Virgil C. Summer Nuclear Station (VCSNS) Units 2 and 3
Combined License Nos. NPF-93 and NPF-94
Docket Nos. 52-027 & 52-028

Subject: LAR 13-38R Revised License Amendment Request:
Auxiliary Building Structural Floor and Roof Details

Revised License Amendment Request:
Auxiliary Building Structural Floor and Roof Details
(LAR 13-38R)

UFSAR Figure 3H.5-6 markups

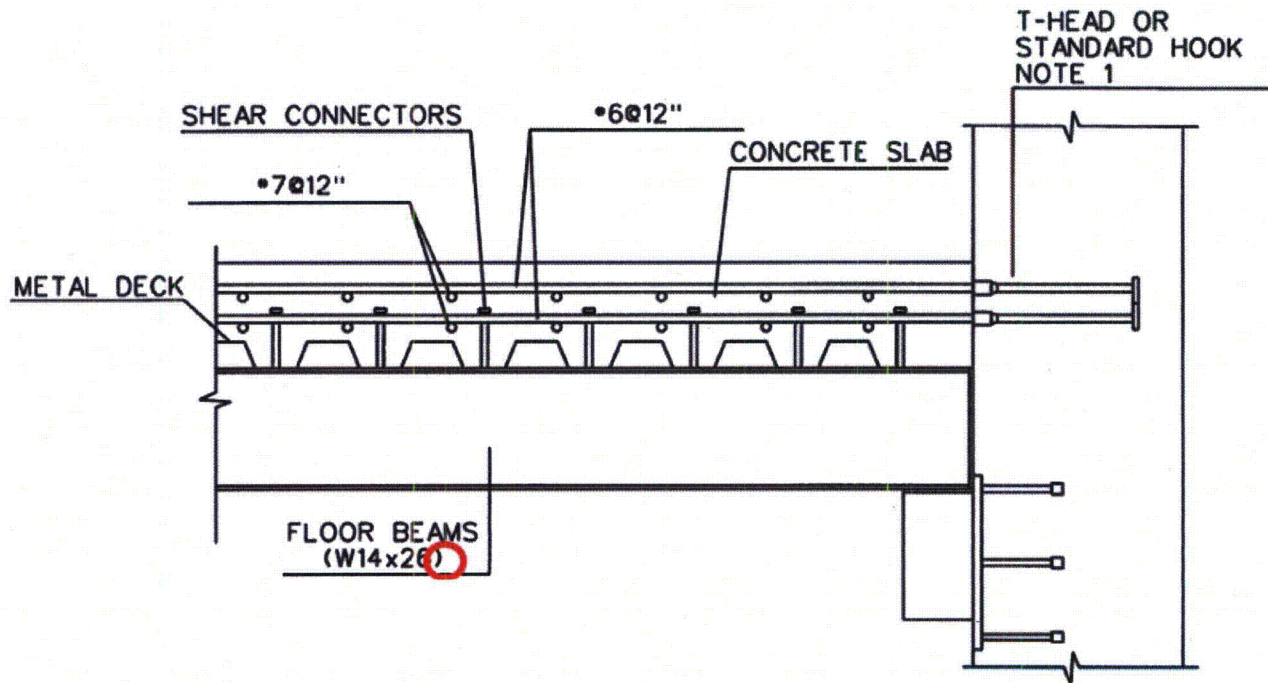
- J. UFSAR Figure 3H.5-6 is revised as follows:
 - 1. In Section A-A; remove the “TYP” from the W14x26 floor beam designation
 - 2. Delete the word “Typical” from the Figure Title

Changes to Figure 3H.5-6 remove the "typical" designation from the figure title and remove the designation of the floor beam size as typical (TYP) since the figure describes a specific critical section. The design of the critical section depicted in UFSAR Figure 3H.5-6 is unchanged.

UFSAR Chapter 3, Appendix 3H, Figure 3H.5-6, [Auxiliary Building Typical Composite Floor]* - Revise Tier 2* information as shown in the figures following this page.

UFSAR Figure 3H.5-8 markups

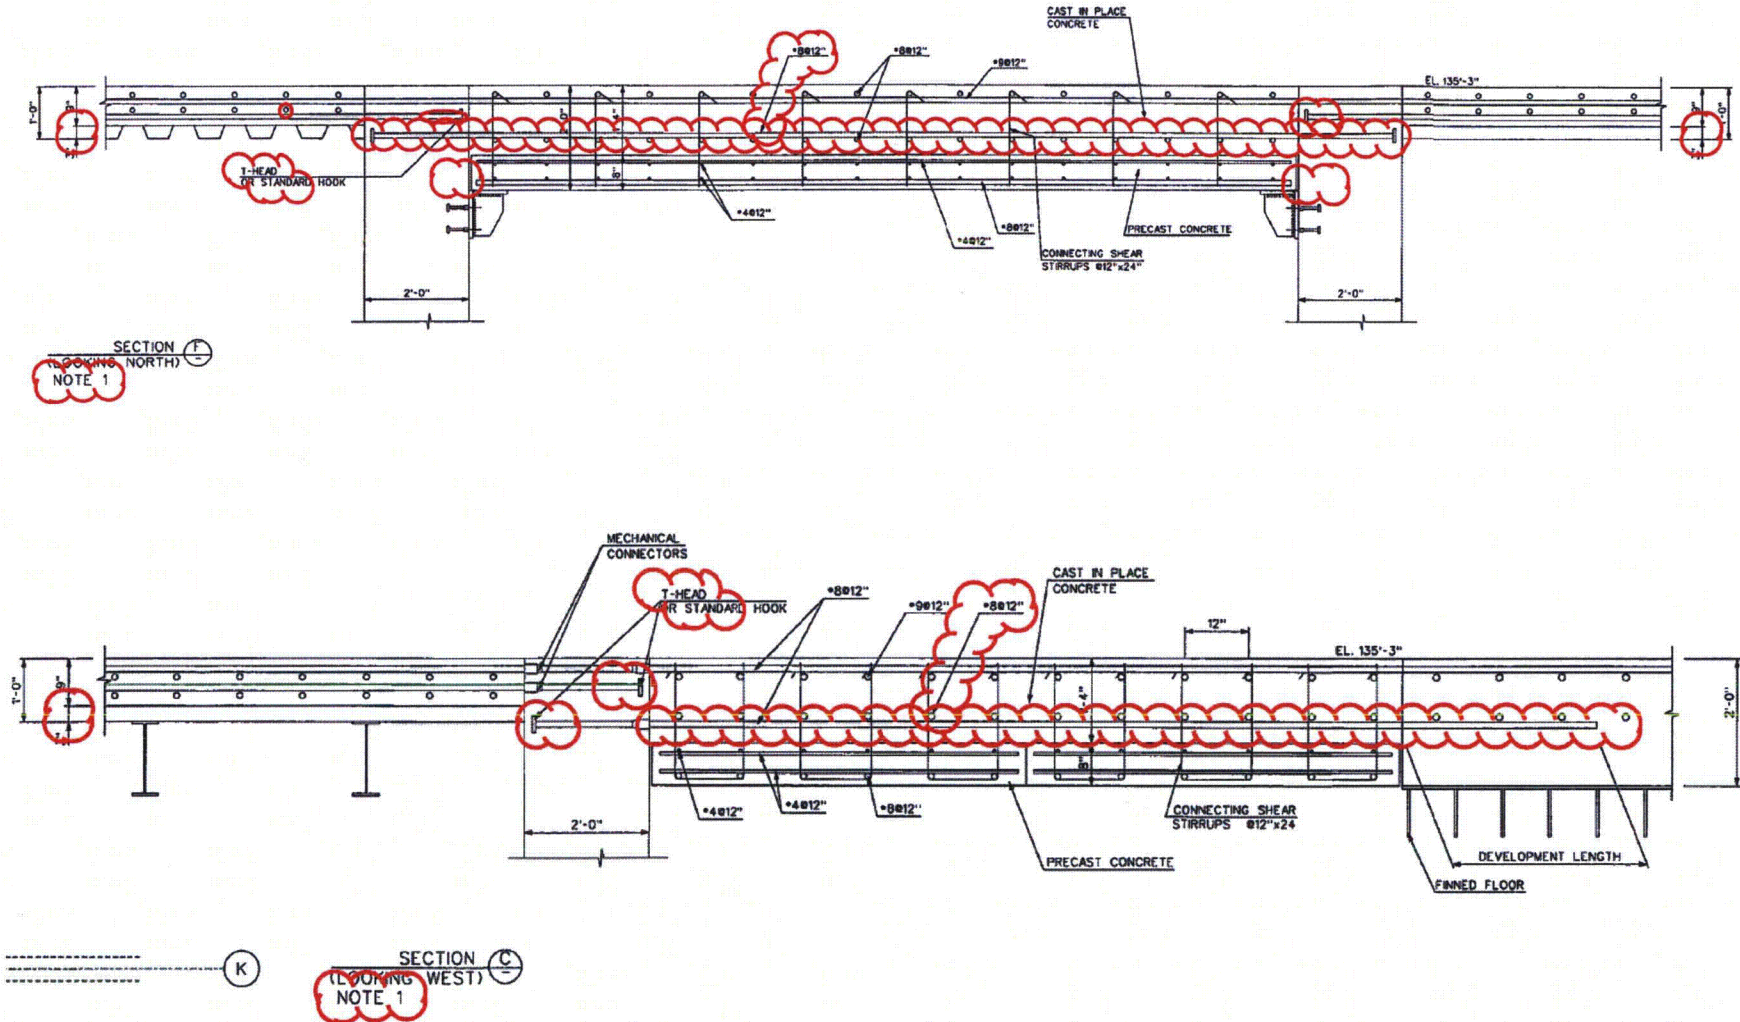
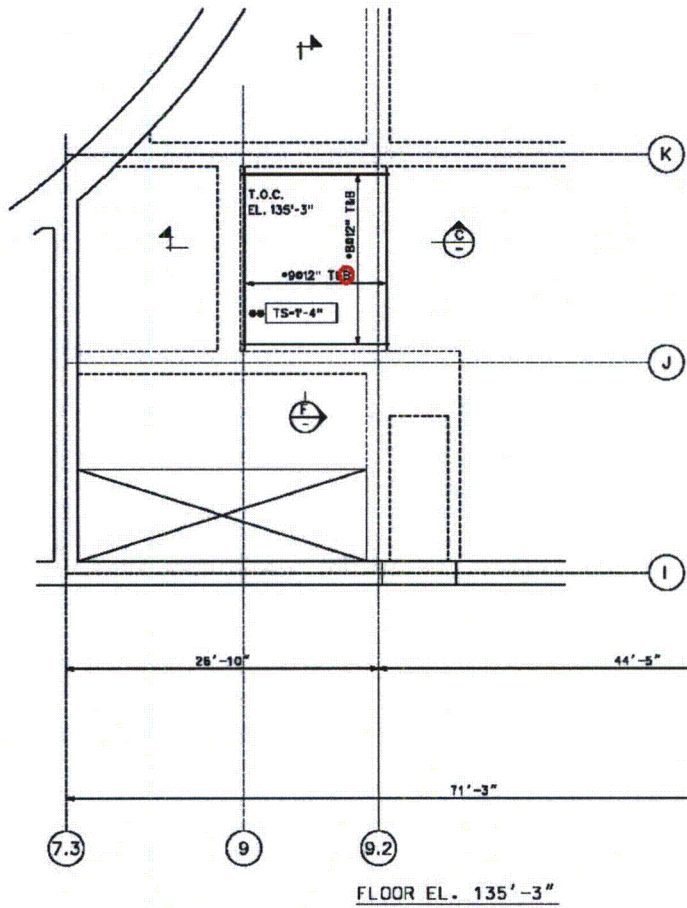
- K. UFSAR Figure 3H.5-8 is revised as follows:
 - 1. In Section F Looking North, replace the bottom #8@12” reinforcement bar extending into the walls with a bar that is contained within the precast panel.

- 2. In Section F Looking North, add a #8@12” reinforcement bar extending into the walls with headed reinforcement to the lower portion of the cast-in-place concrete. Add a label to this bar identifying the #8 @ 12” reinforcement arrangement.

- 3. In Section F Looking North, extend the length of the reinforcement bars terminated with headed reinforcement
 - 4. In Section F Looking North, on the left side of the section view, replace “Anchor Plate” with “T-Head”

- 5. In the floor in the left side of the Section F View shift the misplaced small circle representing a north south reinforcement bar to the correct location above the east west rebar.

- 6. At each end of the Section F View the drawing convention to define the 3 inch distance is changed to move the arrows.
 - 7. To the Label “Section F Looking North” add “Note 1”

8. In Section C Looking West, extend the length of the reinforcement bars terminated with headed reinforcement
9. In Section C Looking West, add designation of perpendicular longitudinal reinforcement above lower reinforcement bar in cast-in-place concrete and add arrow from #8@12" to rebar.

10. In Section C Looking West, replace "Anchor Plate" with "T-Head"
11. At the left end of the Section C View, drawing convention to define the 3 inch distance is changed to move the arrows.

12. Remove the view showing the details of the precast panel reinforcement for floor elevation 133' 11". [The thickness of the precast panel is discussed in UFSAR Subsection 3H.5.3 and the reinforcement for the precast panels is provided in Section C and Section F of Figure 3H.5-8.]

13. To Label "Section C Looking West" add "Note 1"
14. In FLOOR EL. 135' 3" view add "B" to #8@12" to designate Bottom rebar.
15. Add the following Note 1 to the figure "Refer to Subsection 3.8.4.4.1 for the requirements for development of headed reinforcement"

UFSAR Figure 3H.5-8 is revised to change the representation of the flexural reinforcement design shown in the figure. The original figure shows reinforcement extending from the precast panel into the adjacent wall. This design is changed to support construction sequencing in which concrete for the walls is placed before the precast panel is put in place. The figure is changed to show the reinforcement

terminating within the precast slab and reinforcement added to the bottom of the cast-in-place portion. This additional reinforcement in the cast-in-place portion extends into the wall. A plan view showing the reinforcement for the precast panels is removed because the information is provided elsewhere on the figure and in the licensing basis. The figure is also changed to fix discrepancies with drawing convention.

UFSAR Figure 3H.5-8 is also changed to modify the location of the T-Heads on headed reinforcements to be consistent with the criteria for development of headed reinforcement. The description on the figure for the anchoring of reinforcement is changed from Anchor Plate to T-Head to accurately reflect the used of headed reinforcement. A note referring to UFSAR Subsection 3.8.4.4.1 for the requirements for development of headed reinforcement is added to the figure. These criteria use ACI 318-11, Section 12.6, requirements and have been previously approved and incorporated into the licensing basis as part of the license amendment to include the use of headed reinforcement above the basemat. UFSAR Subsections 3.8.3.5, 3.8.4.4.1, and 3.8.4.5.1 of the licensing basis were previously revised with a license amendment request to incorporate these criteria. See SCE&G COL Amendments 2 and 5 (Adams Accession Numbers ML13056A183 and ML13149A314, respectively). The figure is also changed for consistency with drawing conventions.

The changes to the reinforcement in USFAR Figure 3H.5-8 are incorporated to provide reinforcement in the cast-in-place concrete consistent with the analysis to resist the loads in the cast-in-place concrete without relying on the reinforcement in the precast panels. The figure is also revised to make an editorial change to be consistent with drawing conventions. The revised design continues to be in conformance with ACI 349. The drafting convention changes do not change design information or design requirements. The removal of the plan view showing the reinforcement for the precast panels does not remove or change design information because the information is provided elsewhere on the figure and in the licensing basis. The thickness of the precast panel is discussed in UFSAR Subsection 3H.5.3 and the reinforcement for the precast panels is provided in Section C and Section F of UFSAR Figure 3H.5-8.

UFSAR Chapter 3, Appendix 3H, Figure 3H.5-8, [Auxiliary Building Operations Work Area (Tagging Room) Ceiling]* - Revise Tier 2* information as shown in the figures following this page.
